Ref: FCC Class II Permissive change for FCC ID: ZPNVS60U029

Applicant: CUB ELECPARTS INC.

This is to request a Class II permissive change for FCC ID: ZPNVS60U029
, originally granted on 03/14/2019

Attachment_ Description of the adjustments

1. 電池更換成新廠商

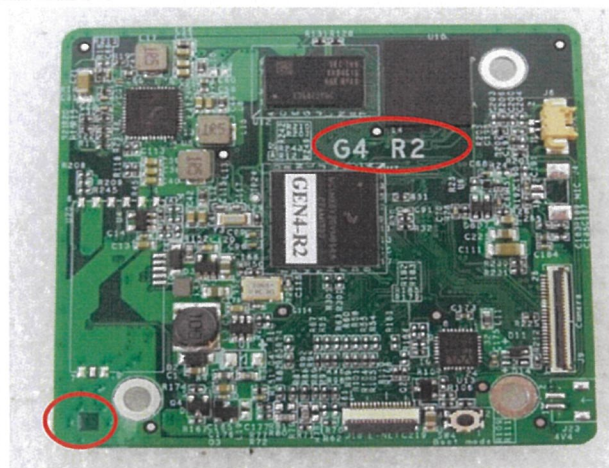
New battery manufacturer

2. OS 版因應製成需求做進版，所以更換天線位置

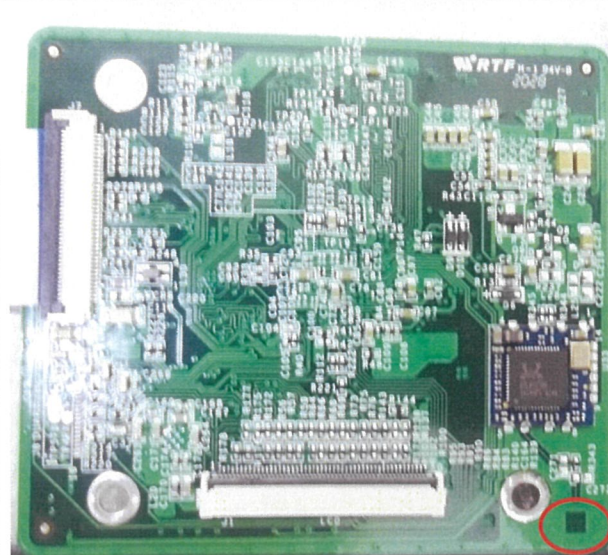
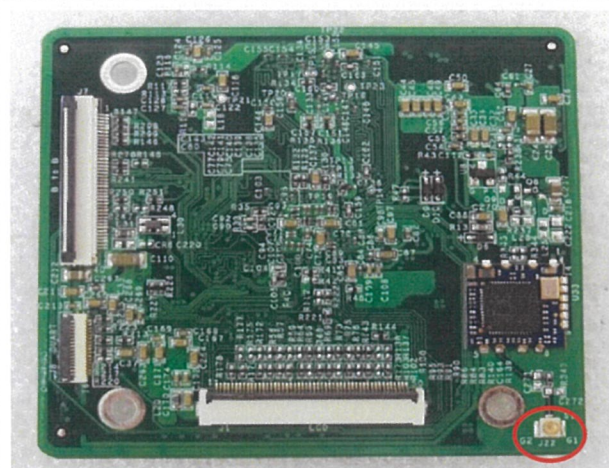
OS board is updated based on the production requirements. The antenna location is changed.

3. 主板更換電容位置&還有增加 ESD 保護元件

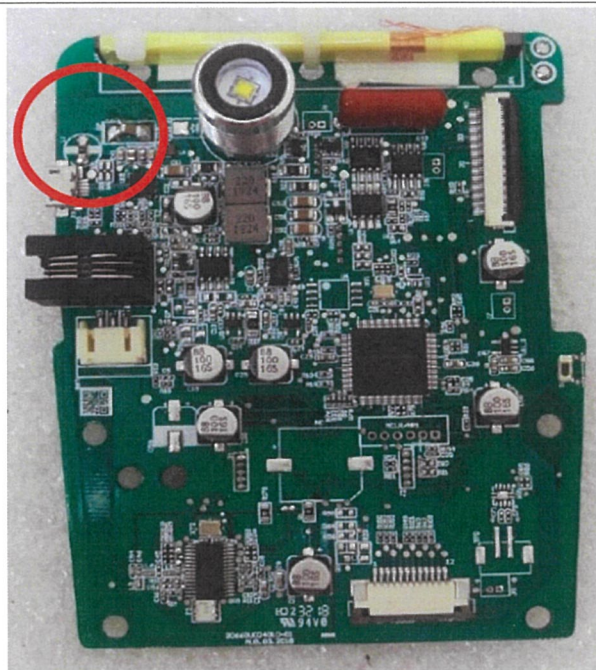
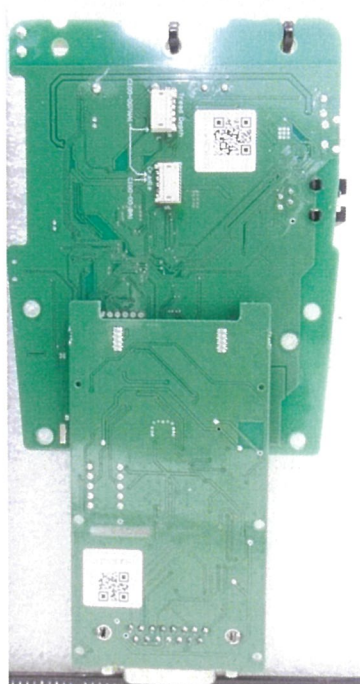
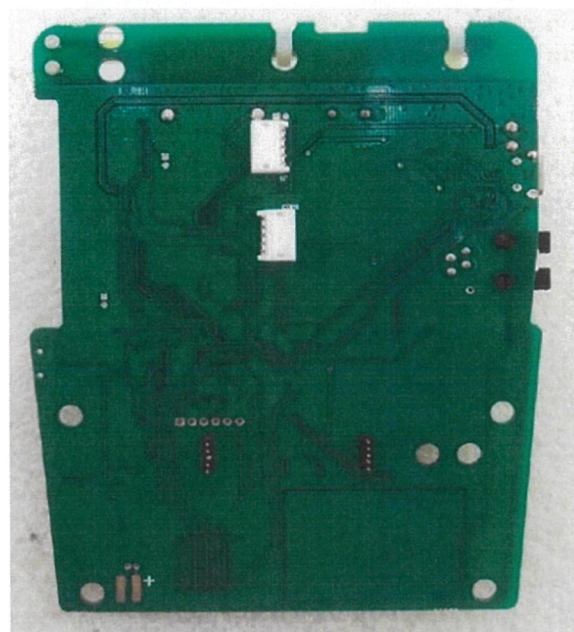
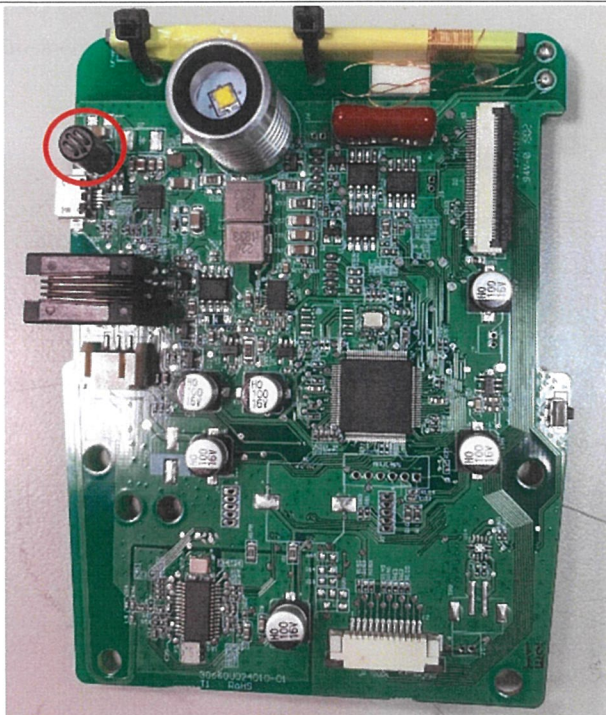
Capacitor's location is changed and additional ESD protective units are added on the main board.

4. 製成改鎖螺絲

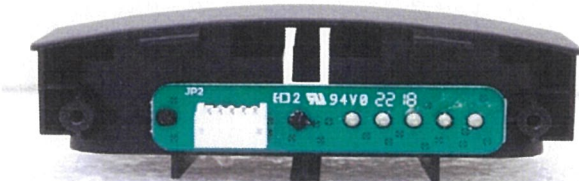
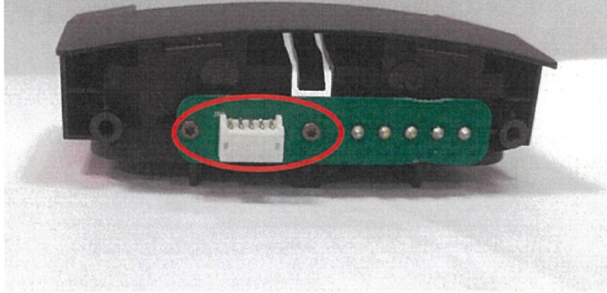
Manufacture assembly method is changed into screw fixation.

5. 因應工程要求修改連接器(SMD)，有更動元件位置

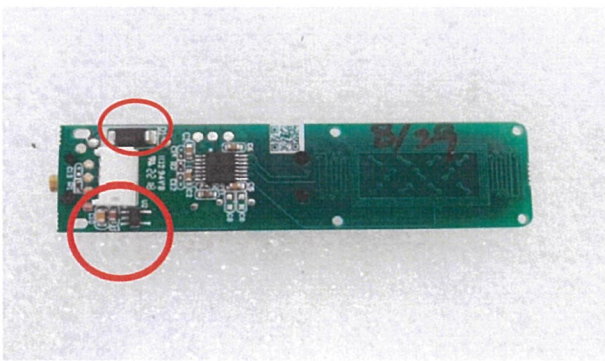
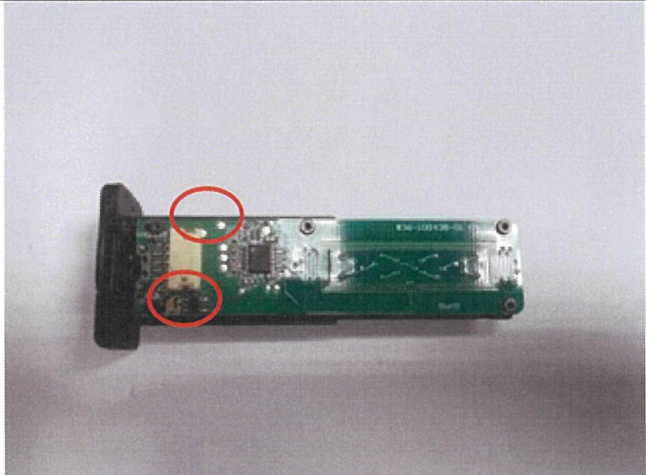
Based on the manufacture requirements, the components are changed from DIP to SMD.

6. 新電池外觀

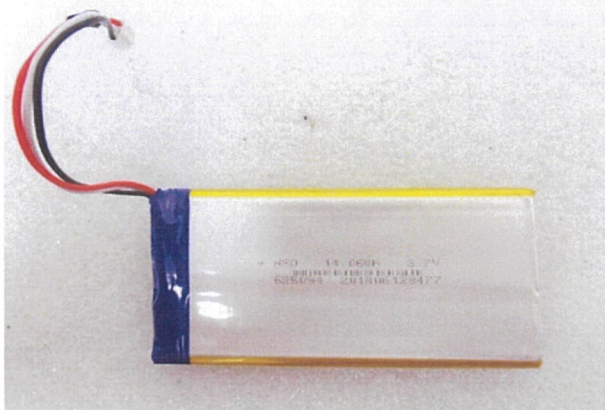
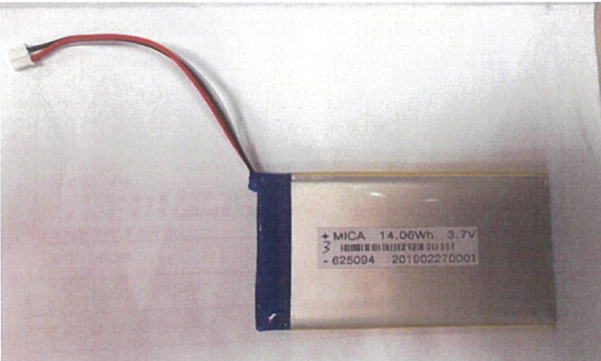
New battery appearance

7. Cradle PCB 差異

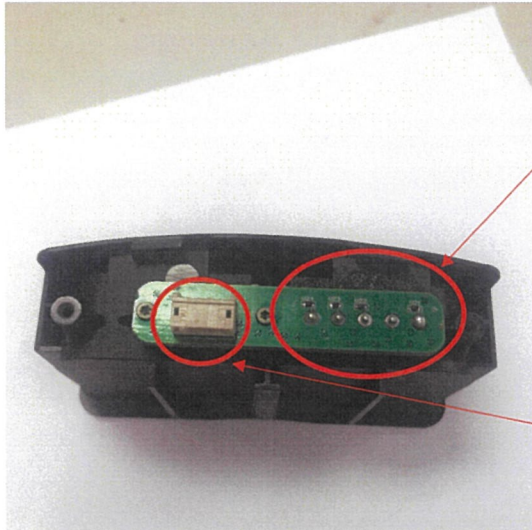
The adjustment of Cradle PCB

4 additional ESD protective units are added next to the 5 PIN

The 5 PIN connector can be changed into SMD so that only programming probes are required to be welded when the PCBA is ready.

8. PCB 差異

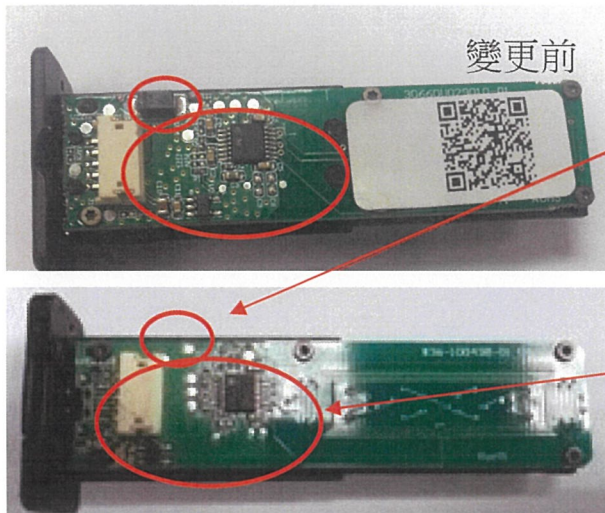
因應電磁閥取消，拿掉二極體
Diode is removed in accordance to the removal of Solenoid valve.

微調元件位置
The units are slightly relocated.
